# INNER WEST COUNCIL

## DEVELOPMENT ASSESSMENT REPORT

<b>Application No.</b>	DA201700579
<b>Address</b>	68 Railway Street, Petersham
<b>Proposal</b>	To demolish part of the premises and carry out ground, first and second floor alterations and additions to a dwelling house and construct a new roller door with brick surrounds and hardstand at the rear
<b>Date of Lodgement</b>	23 November 2017. Additional information submitted on 24 January 2018 and 19 February 2018
<b>Applicant</b>	Brad Inwood Architects
<b>Owners</b>	MVB Pty Ltd (Mark Bortolussi, Director)
<b>Number of Submissions</b>	Nil
<b>Value of works</b>	\$200,000
<b>Reason for determination at Planning Panel</b>	Clause 4.6 variation to maximum height of building development standard
<b>Main Issues</b>	Height of building, Heritage Conservation (dormer window)
<b>Recommendation</b>	Consent subject to conditions

*Image 1: Non-compliance with building height standard*

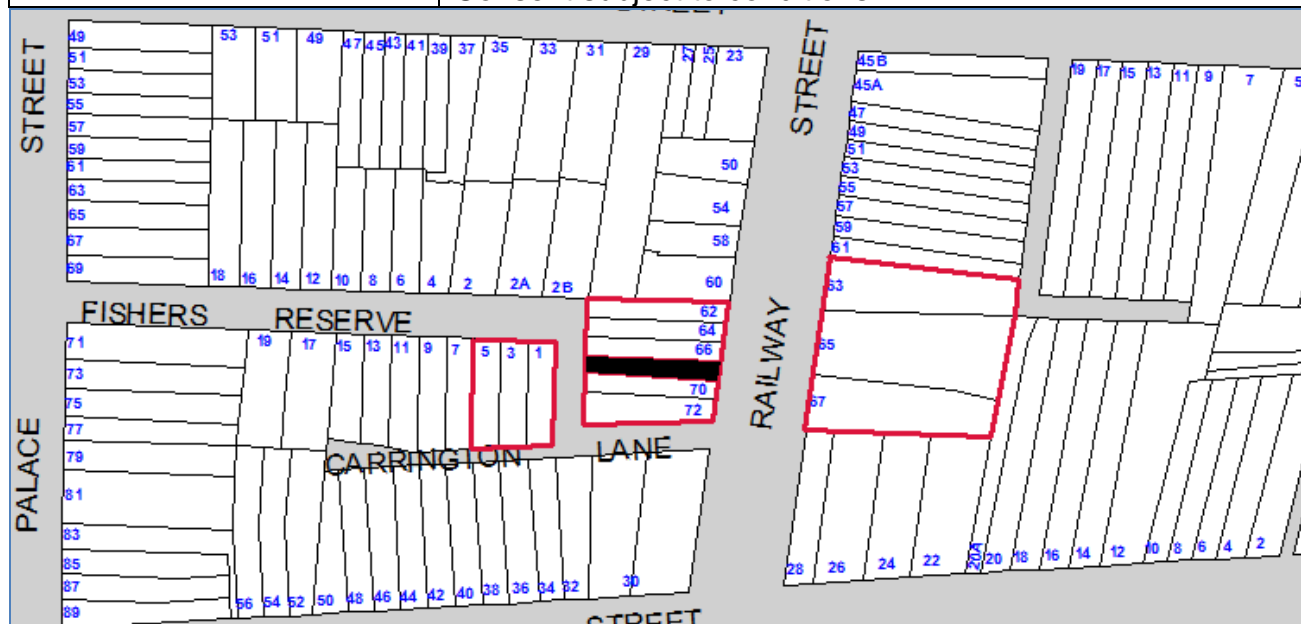
A maximum building height of 9.5 metres applies the site MLEP 2011. The proposed development has a maximum building height of 11.1 metres which does not comply with the height development standard.

The Clause 4.6 written request is assessed as acceptable and worthy of support. The existing development already exceeds the maximum height of building development standard and the height departure of 1.6m or 18% is associated with the introduction of dormers.

Notwithstanding, it is noted that the front dormer is not supported on heritage grounds and is recommended to be deleted as a proposed condition of consent.

**GROUND FLOOR**

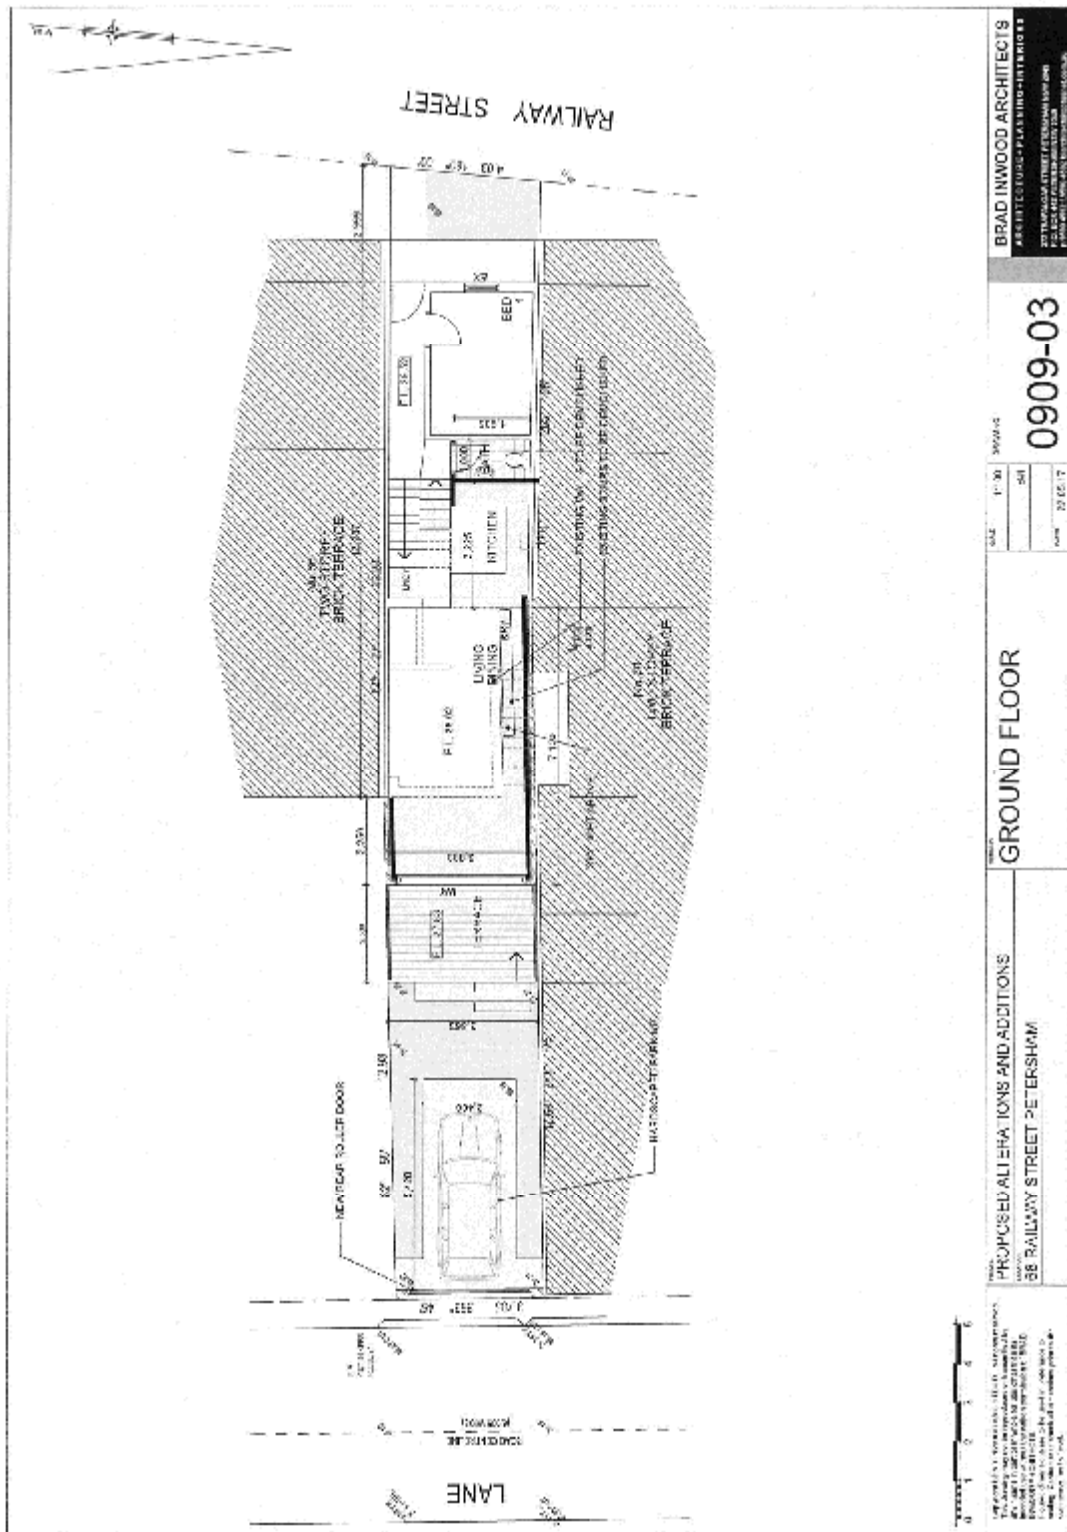
The proposal results in approximately 13sqm of pervious landscaping which does not constitute the required '50% of the required open space as pervious'. Notwithstanding the level of soft/pervious landscaping is considered reasonable given the small size of the site.

A condition is included in the recommendation requiring amended plans to be submitted to the Principal Certifying Authority prior to issue of a Construction Certificate, demonstrating that the areas indicated in the colour green on the approved ground plan consist of soft/pervious landscaping.

- (i) The deletion of the front dormer window with the front roof plane to remain unchanged; and
- (ii) The areas identified with the colour green on the approved ground floor plan consisting of soft/pervious landscaping (i.e. grass, shrubs and trees) with the details of such landscaping being clearly indicated on the amended plans.

**ROOF PLAN**

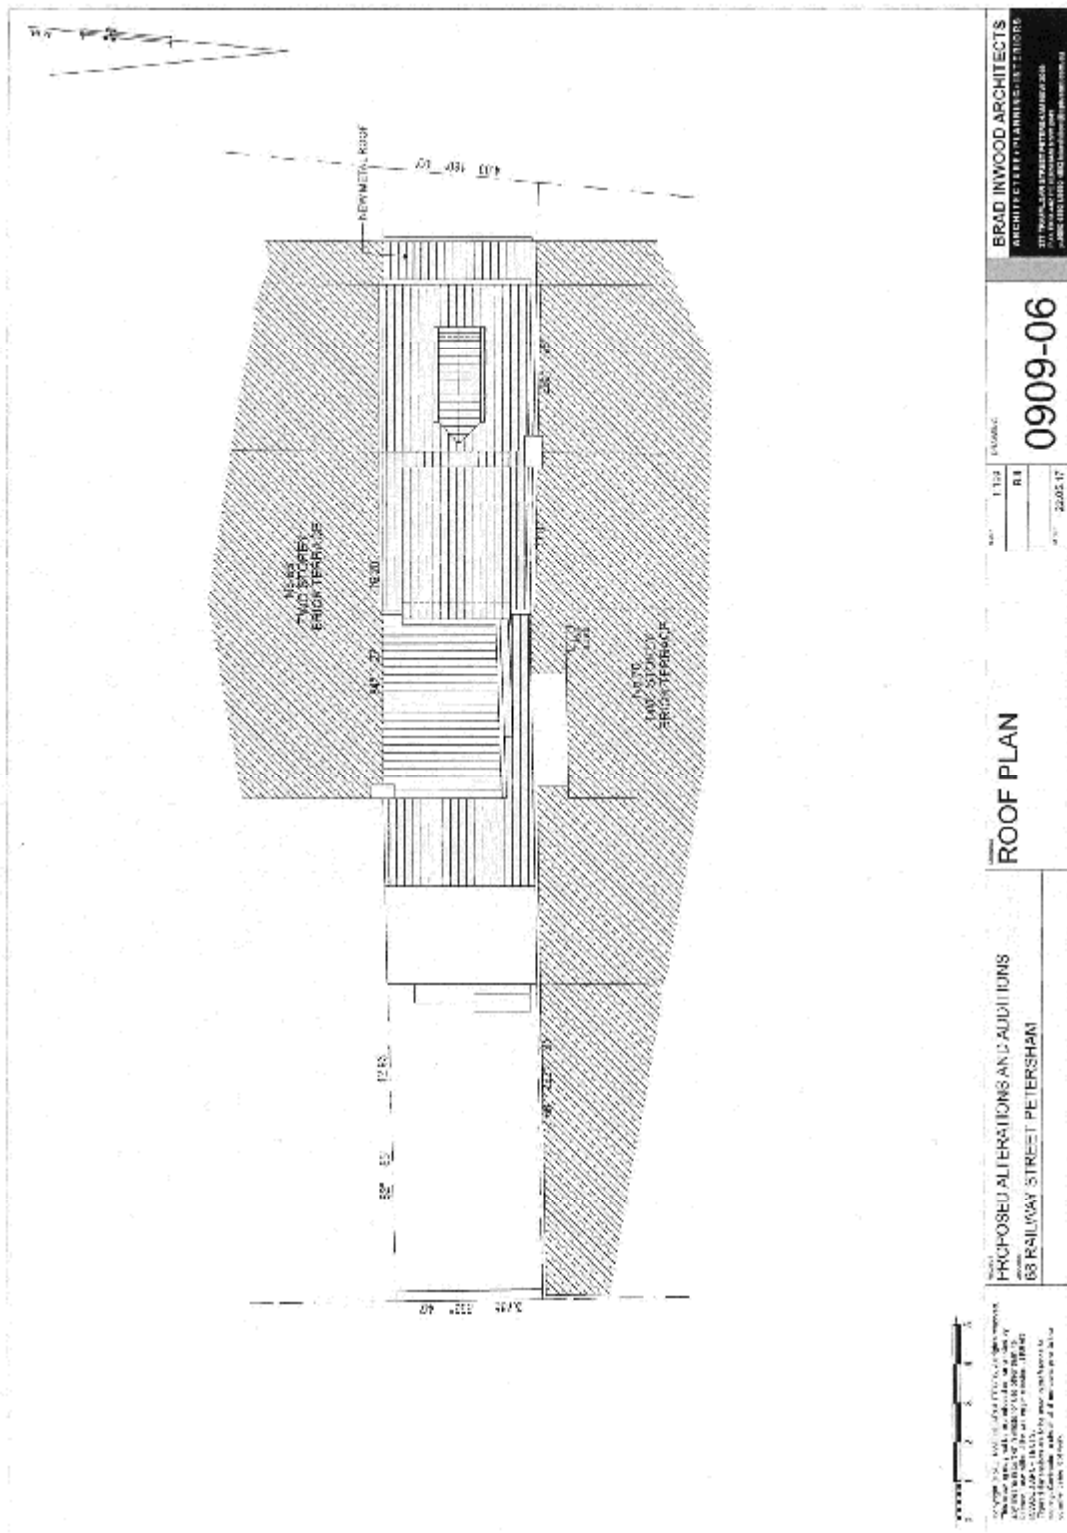
*“The proposal is generally sympathetic to the existing qualities and characteristics of the existing terrace and terrace group and proposes reasonably sympathetic alterations and additions to the rear. The proposal does however propose a street facing dormer, which is uncharacteristic and historically not associated with the terrace and group. The proposed street facing dormer is also inconsistent with MDCP 2011 Part 8.3.2.6 C22.*

*It is recognized the neighbouring property at no. 70 has a front dormer however this is an anomaly amongst an otherwise highly consistent terrace group. The predominant and identifiable uniformity of the group is one of intact street facing*

*roof forms as presented to Railway Street. The terraces are a group of five dwellings, four of which do not have dormers. No. 70 is at the end of the row with a dormer that is not only uncharacteristic of the group, but is also disproportionate in size establishing an undesirable precedent that ideally should not be repeated.*

*Furthermore, the introduction of a street facing dormer poses no real benefit to the attic level. Ample amenity including cross ventilation and daylight is available to the attic level via the rear dormer, and little floor area and head height is gained by its introduction that is otherwise provided by the rear dormer.*

*For the above reasons the proposed dormer is not supported.”*

The front dormer is not supported on heritage grounds and is recommended to be deleted as a proposed condition of consent.
